Houston Lighting & Power South Texas Project Electric Generating Station P. O. Box 308 Bay City, Texas 77414

ST-HL-AE-2607

South Texas Project
Units 1 and 2
Docket Nos. STN 50-498, STN 50-499
AMSAC Diversity

Reference A provided additional information requested by the NRC staff to support review of South Texas Project's AMSAC submittal (FSAR Section 7.8). Subsequent staff review raised additional questions concerning diversity between the Reactor Trip System and AMSAC, as implemented at STP. Specific NRC staff concerns related to (1) the microprocessors used in AMSAC and in the Steam Generator Water Level Compensation System (SGWLCS) portion of the Reactor Trip System (RTS), and (2) the isolation relays used in the actuation circuits. Additional information which is expected to be sufficient to resolve these diversity issues is provided in the Attachments.

FIG. 7.8-2 SHT 1 A

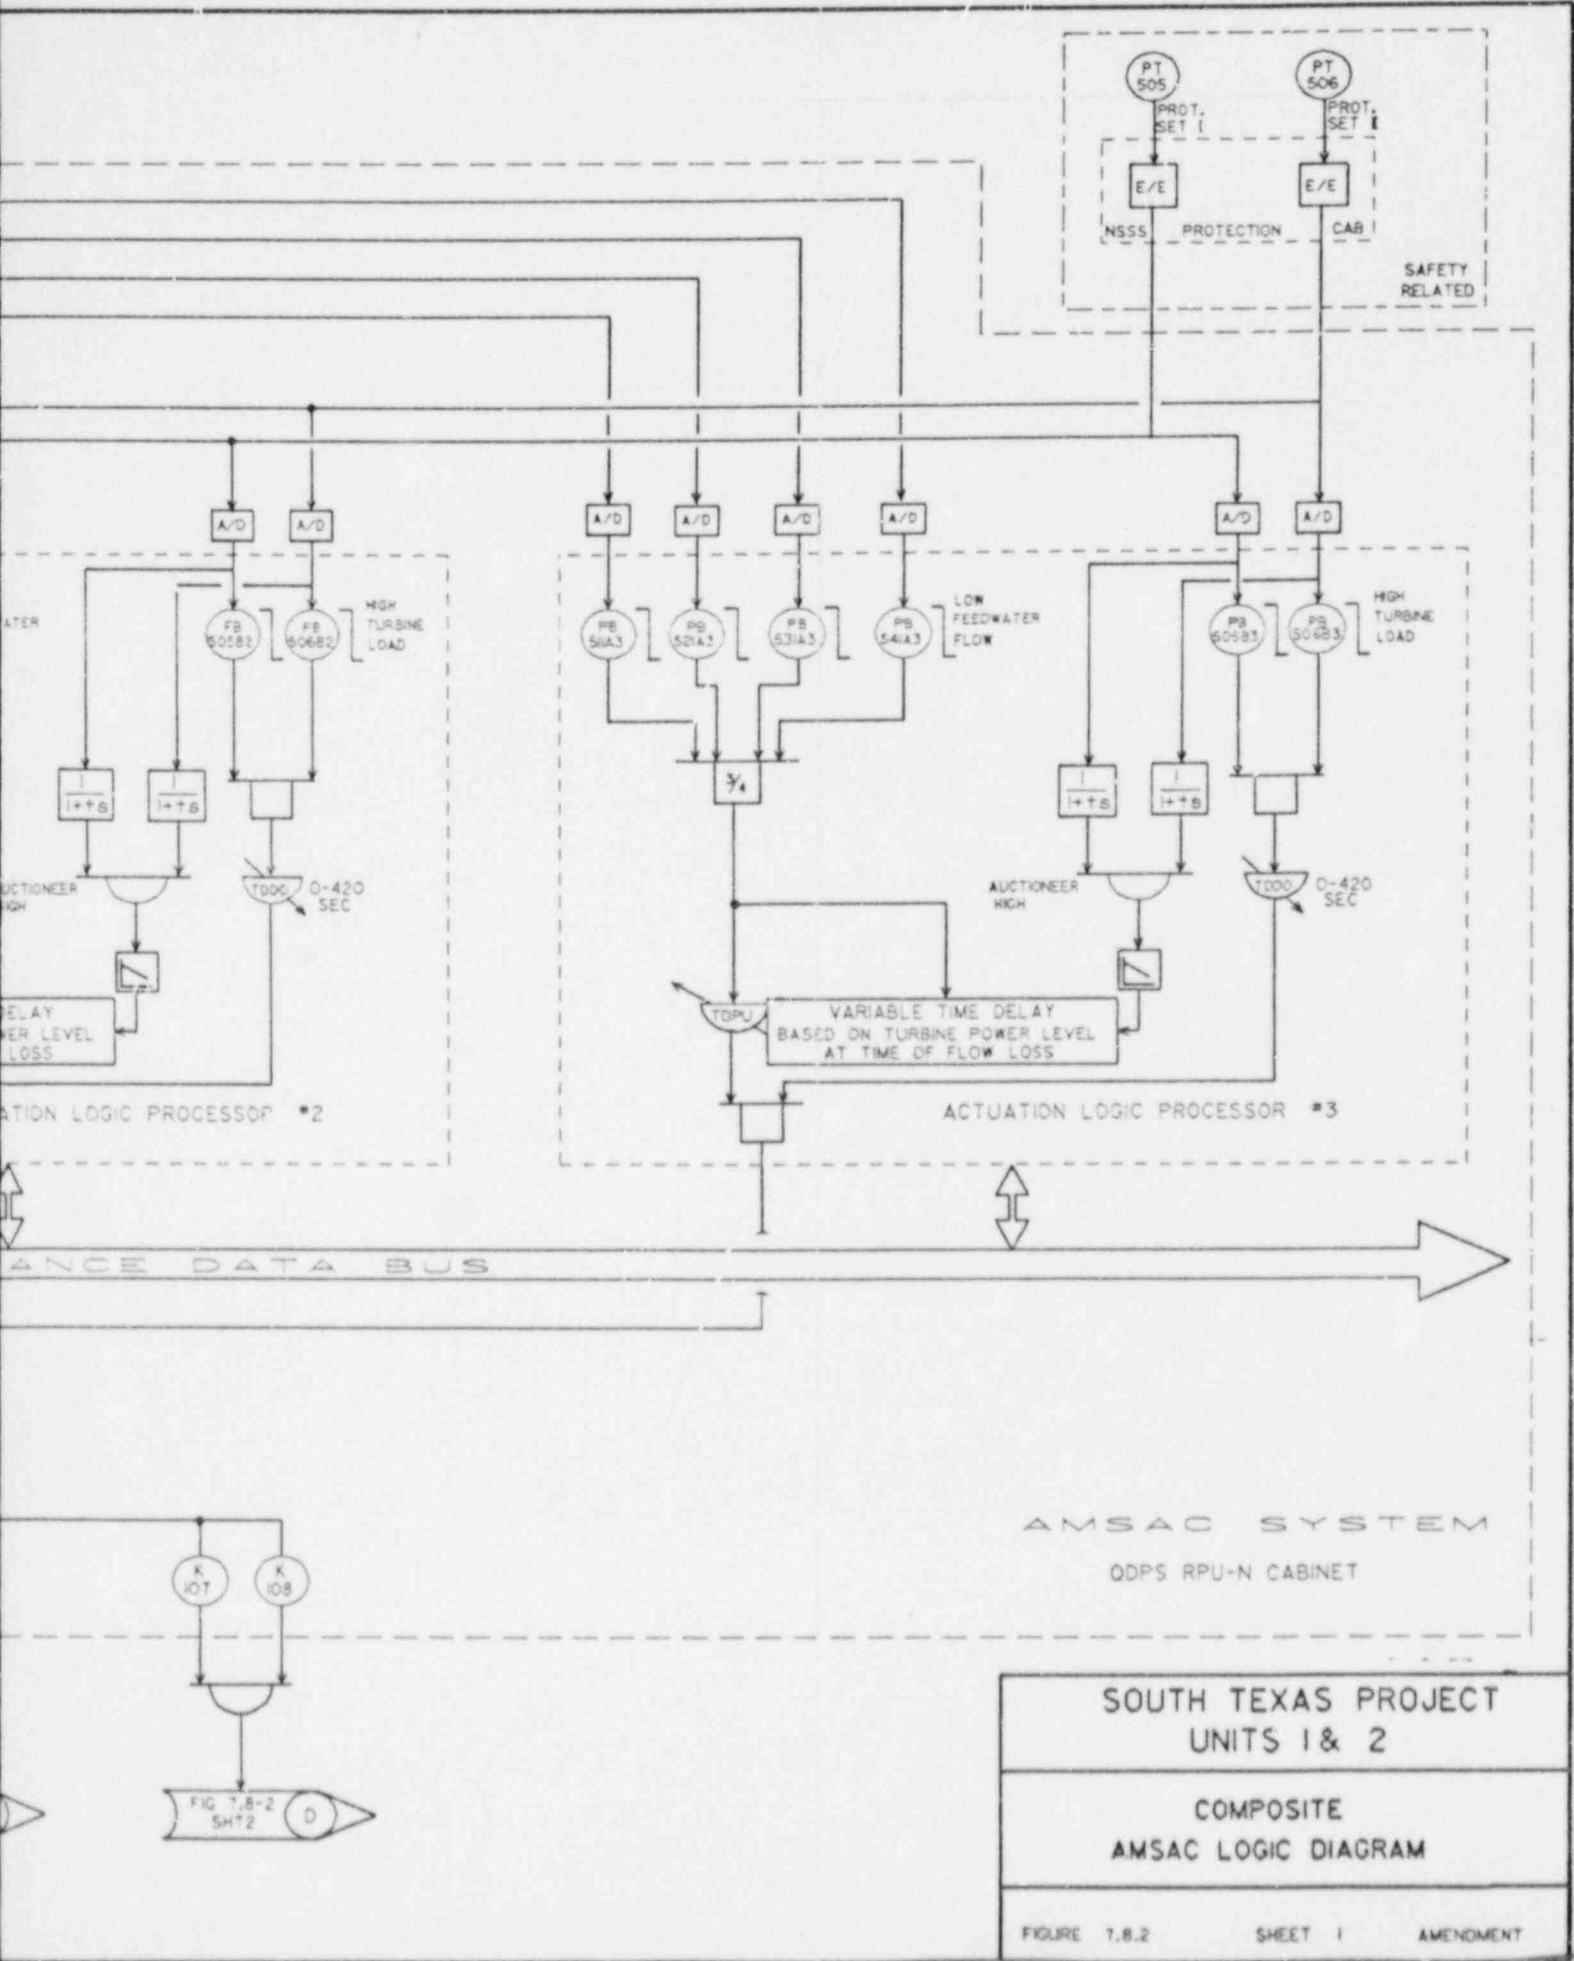
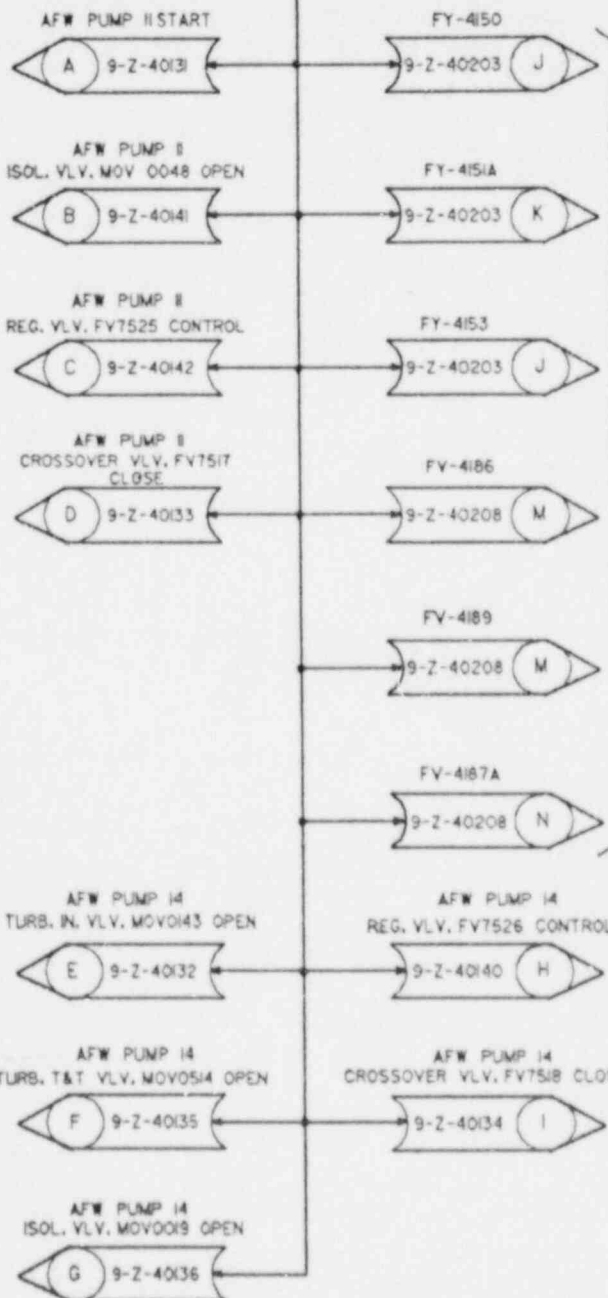
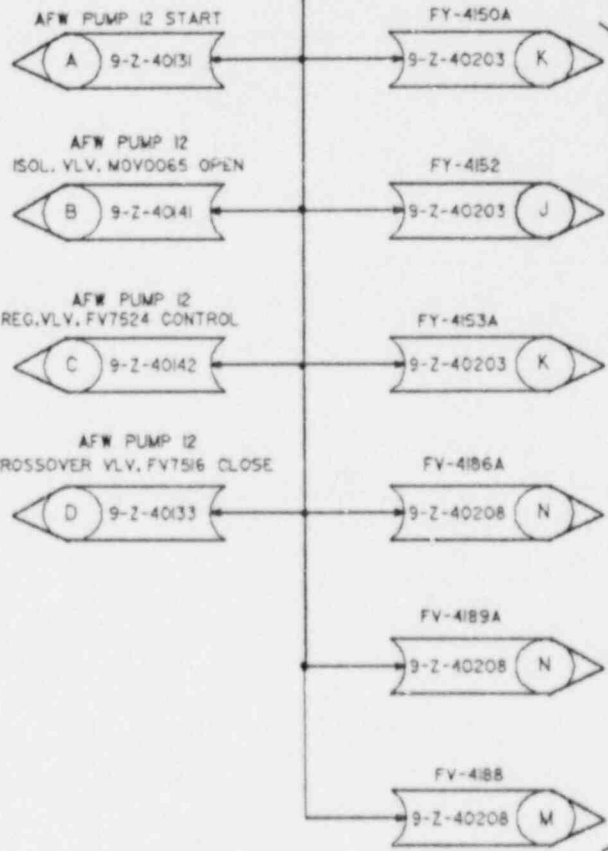
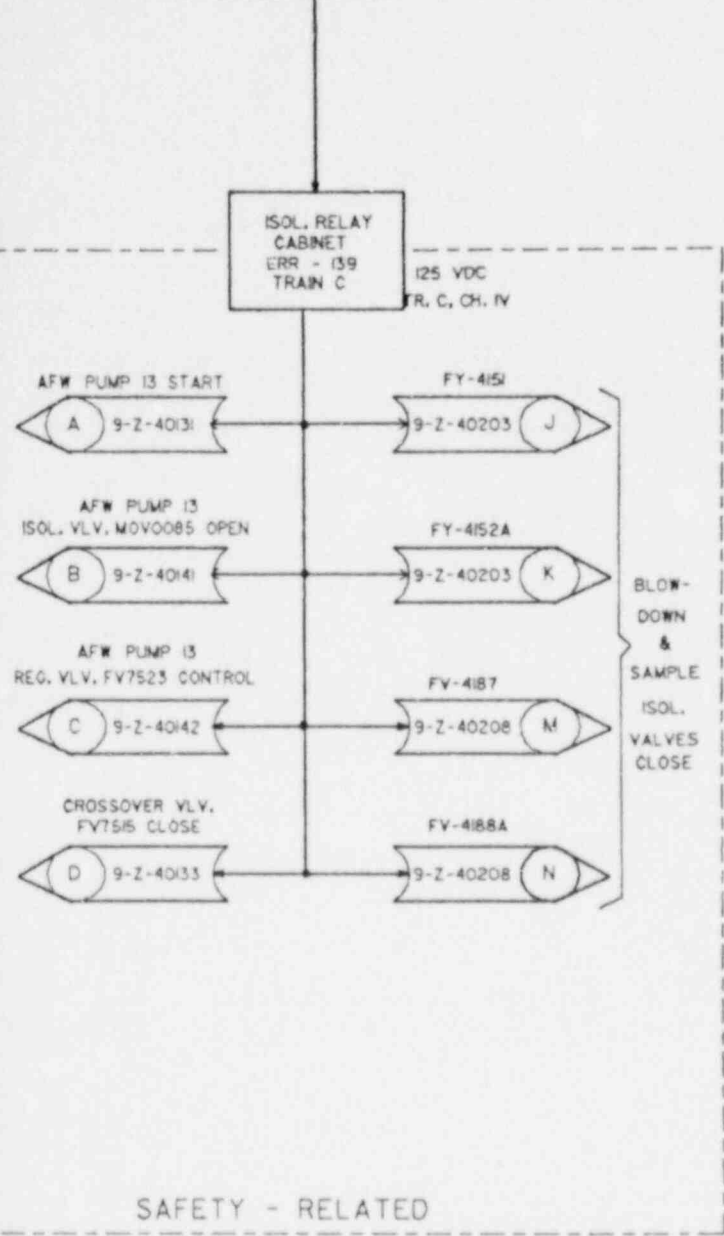
FSAR Figure 7.8-2, Composite AMSAC Logic Diagram, which was requested by the NRC staff and provided in draft form by reference A, has been modified to better show the output actuation logic. Copies are provided as Attachment 3.
